LEVEL-01 TO LEVEL-P2 CMU WALL REINFORCEMENT DETAILS

NO.	FOR APPROVAL	DATE	DESCRIPTION	JOB NAME: RYAN COMPANIES RYAN TOWER	
				DATE	DESCRIPTION
0				JOB NO: 22109	DATE: 09-02-22
1				DETAILS OF: LEVEL-01 TO LEVEL-P2 CMU WALL REINFORCEMENT DETAILS	DATE: 09-02-22
2				DETAILER: SSSTR	DRWG: M01
3				TEXAS REBAR, LLC 817-487-1672

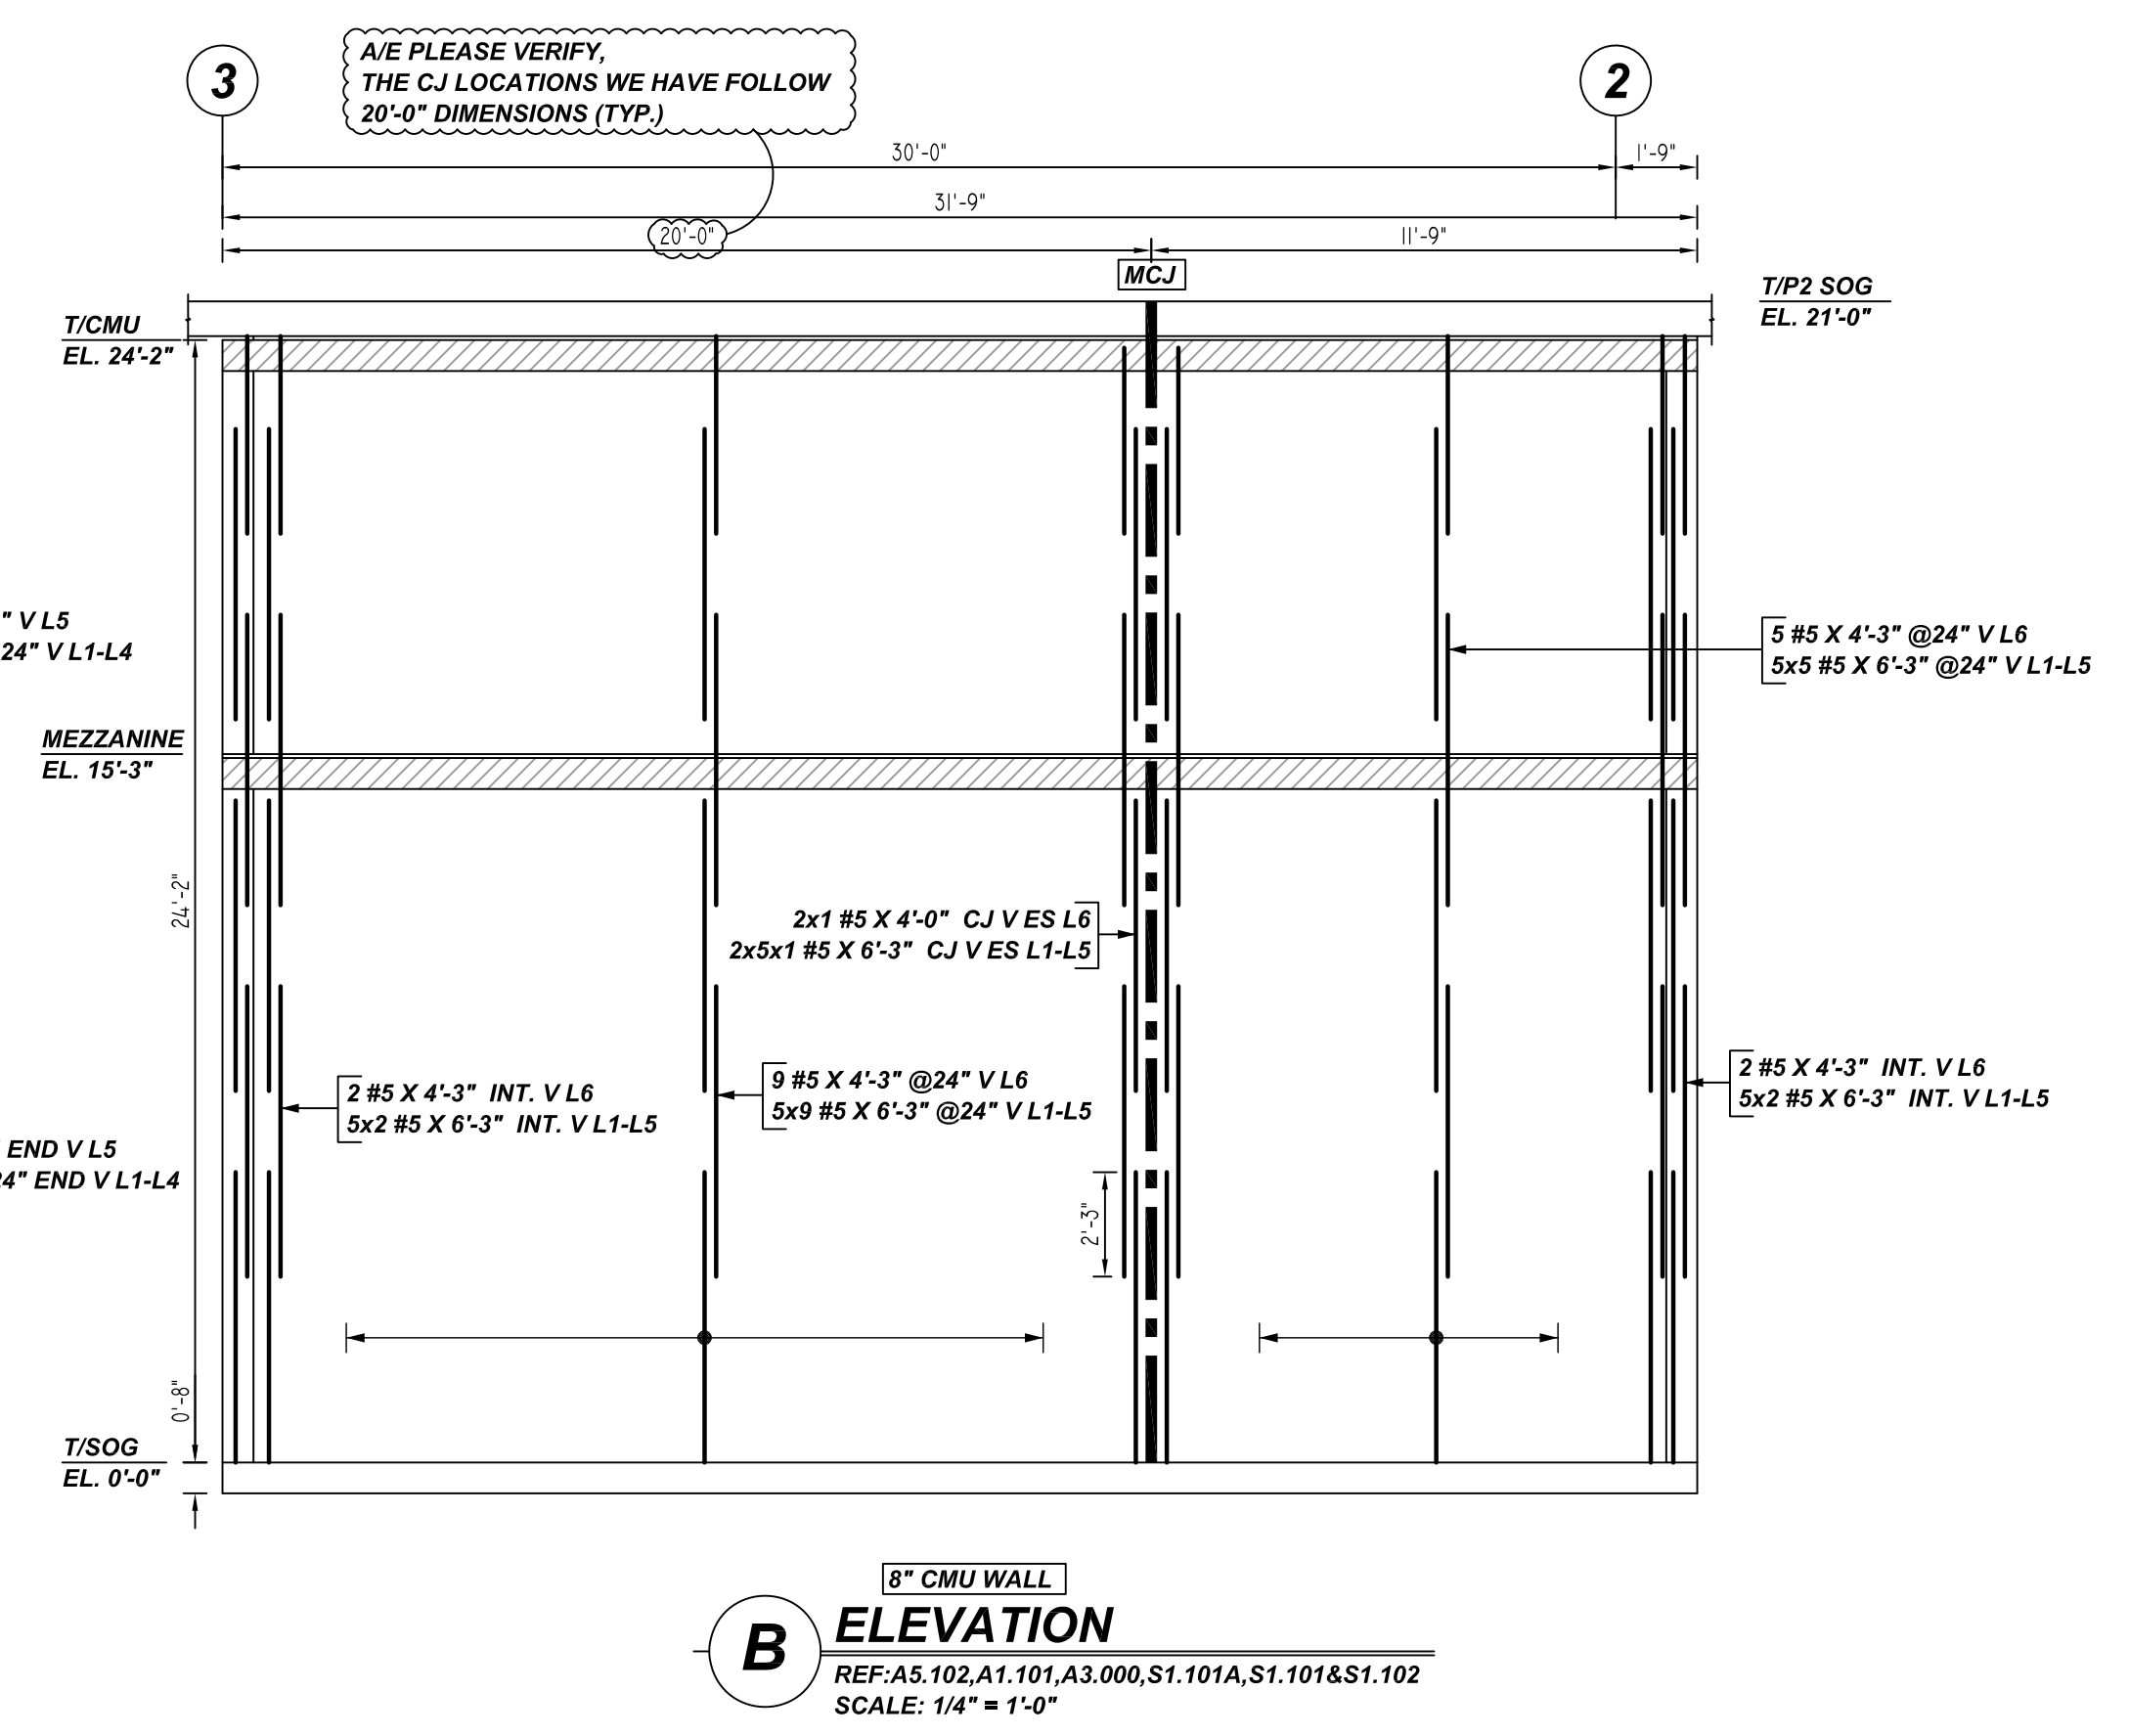
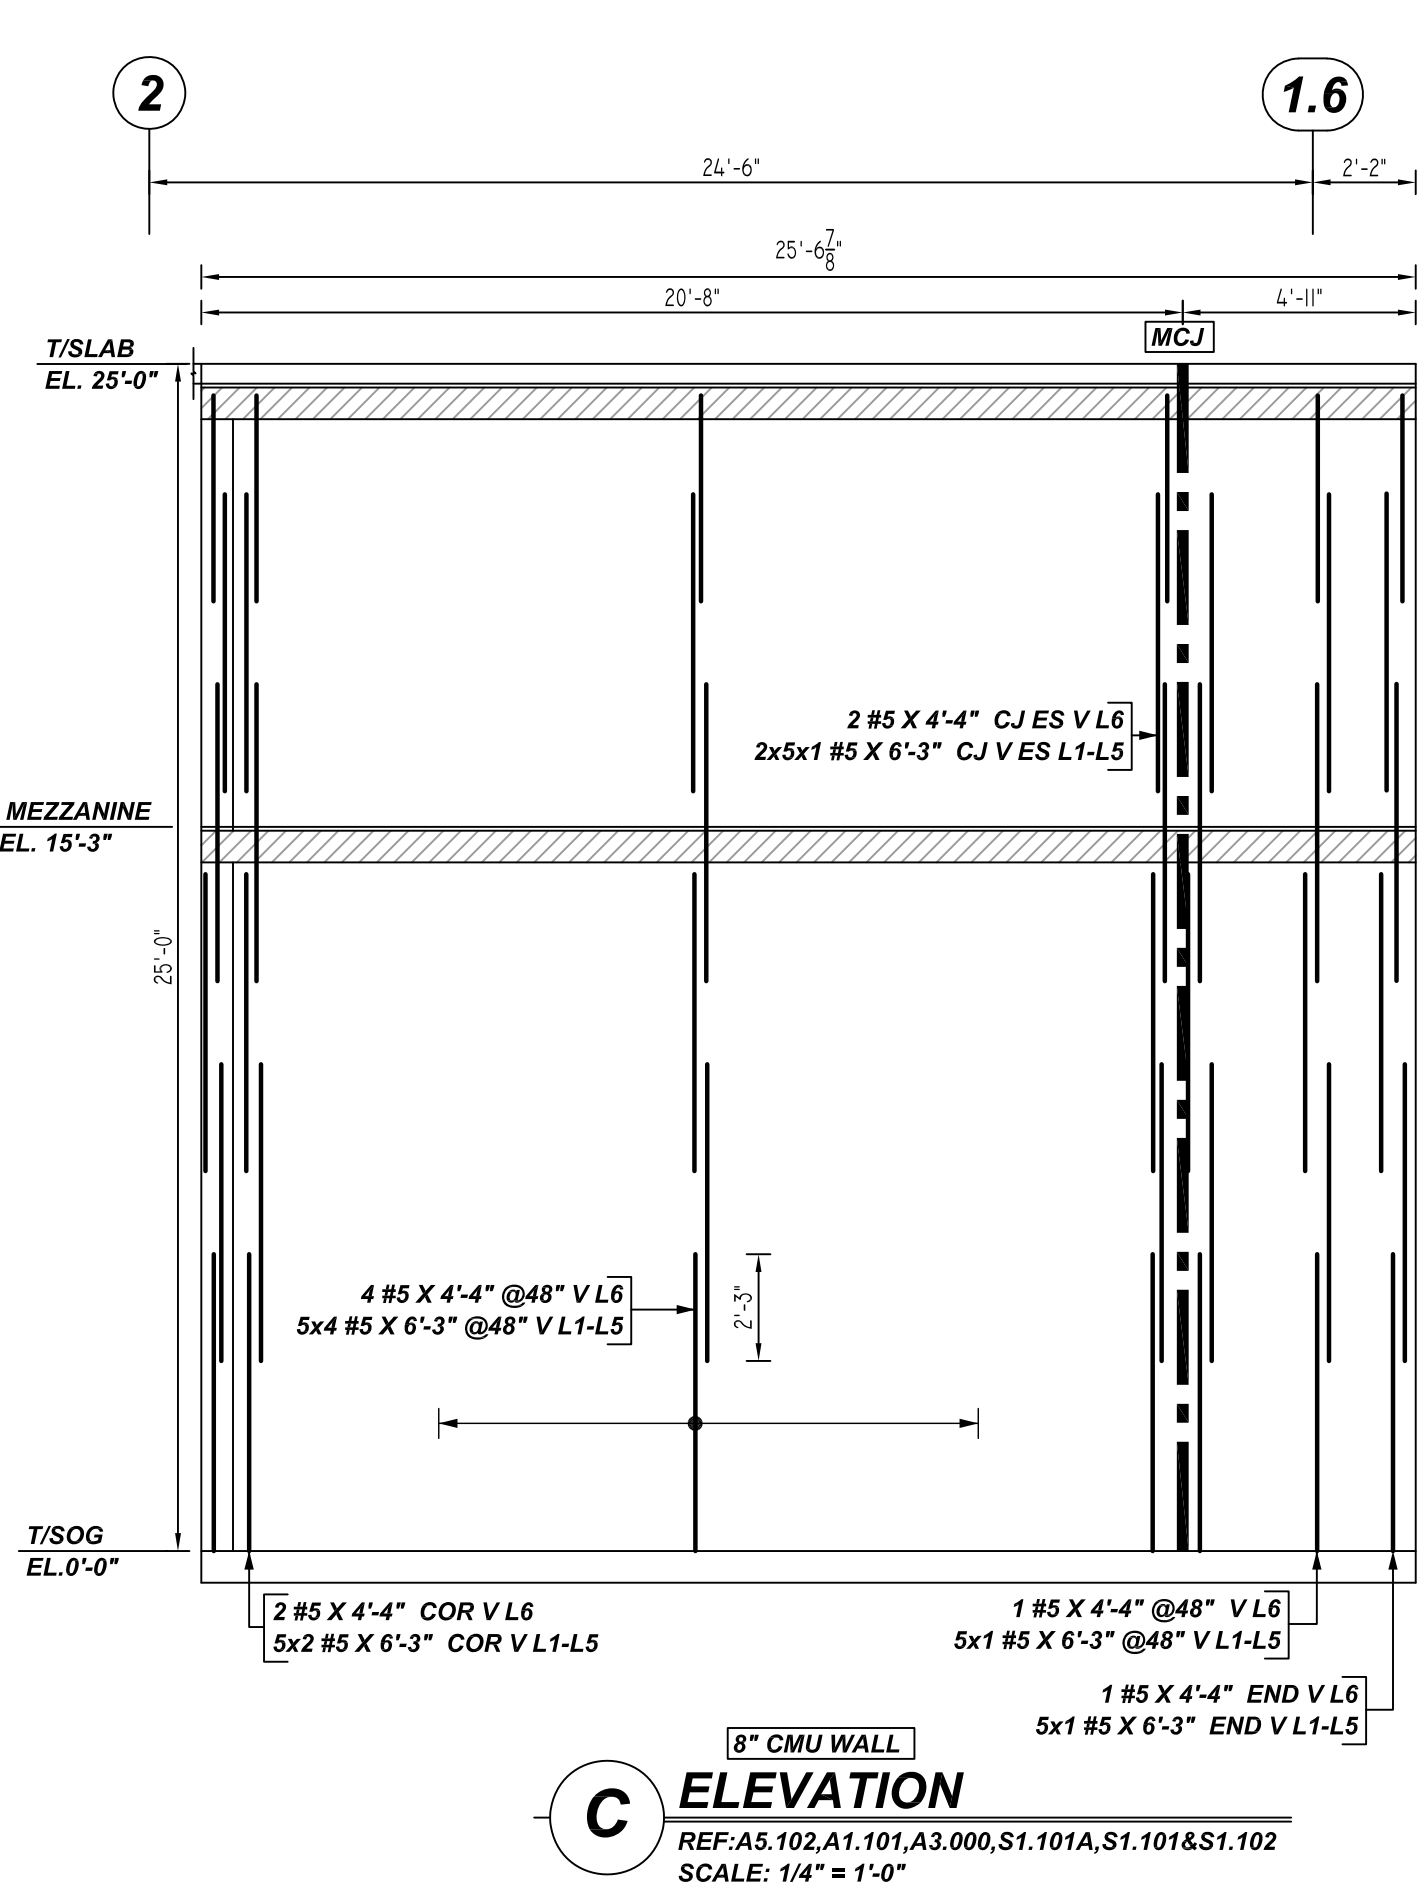
A/E PLEASE VERIFY, THE CJ LOCATIONS WE HAVE FOLLOWED 20'-0" DIMENSIONS (TYP.)
